**INVITATION TO TENDER "ITT" NO. PS20190021
CONSTRUCTION SERVICES FOR THE GRANVILLE BRIDGE REHABILITATION**

QUESTIONS AND ANSWERS NO. 3

ISSUED ON APRIL 15, 2019

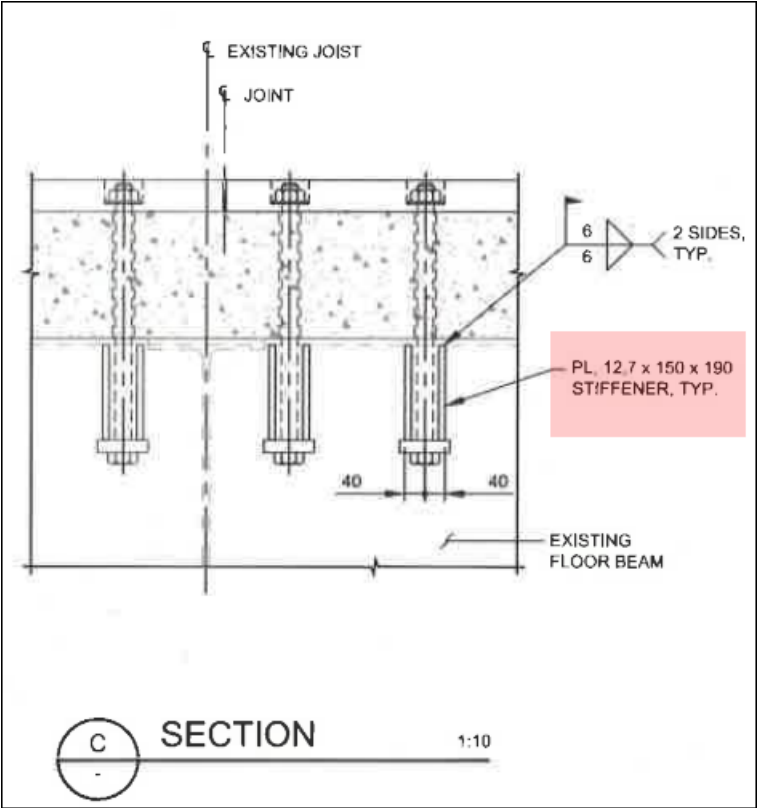
A20	The connection of the seismic isolation bearings to the new bearing plates will be the responsibility of the bearing manufacturer, and will be manufactured to satisfy the design requirements and the 2014 AASHTO Guide Specification for Seismic Isolation Design.
Q21	Drawing 2125-315 Stage 5 states weld new bearing plates to existing bearing plates

as shown protect bearing rubber during welding with fiberglass insulation. Our bearing supplier was concerned about the flatness and warping of 25mm thick plate after welding. Please advise.
A21	Proceed as per the Contract Drawings.
Q22	Both Polychloroprene and natural rubber is mentioned on the finger joint trough material, please specify which material shall be used.
A22	Polychloroprene.
Q23	Dwg No. 2125-201. Design Code 2. Notes "Bearings shall conform to CHBDC". Dwg No. 2125-316. Note 3. Notes "Isolation bearings shall be designed to meet the requirements shown in Table 131 and the 2014 AASHTO Guide Specifications for seismic Isolation Design". Please confirm which design requirements shall be used.
A23	The 2014 AASHTO Guide Specifications for Seismic Isolation Design shall govern the design of the isolation bearings.
Q24	The isolation bearings specification calls for prime + finish coat. Please specify what is the final coat of exposed steel on the isolation bearings.
